Service Information Clutch Disks with Rubber Torsional Dampers Replaced

Porsche	924	2.0	Turbo
		2.5	S
	944	2.5	
		2.5	S
		2.7	
		3.0	S2

Fig. 1: Clutch disks, Porsche

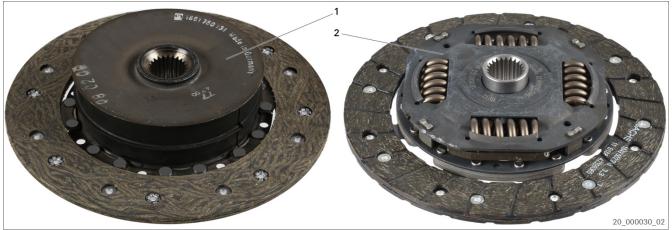
In cooperation with Porsche, all clutch disks were converted from rubber torsional dampers (1) to torsional dampers with springs (2). Despite the great visual differences, all dimensions and functions are identical. The clutch disk can be installed without any restrictions.

Before installing, measure the lateral run-out of the clutch disk and align as needed (0.5 mm max.).
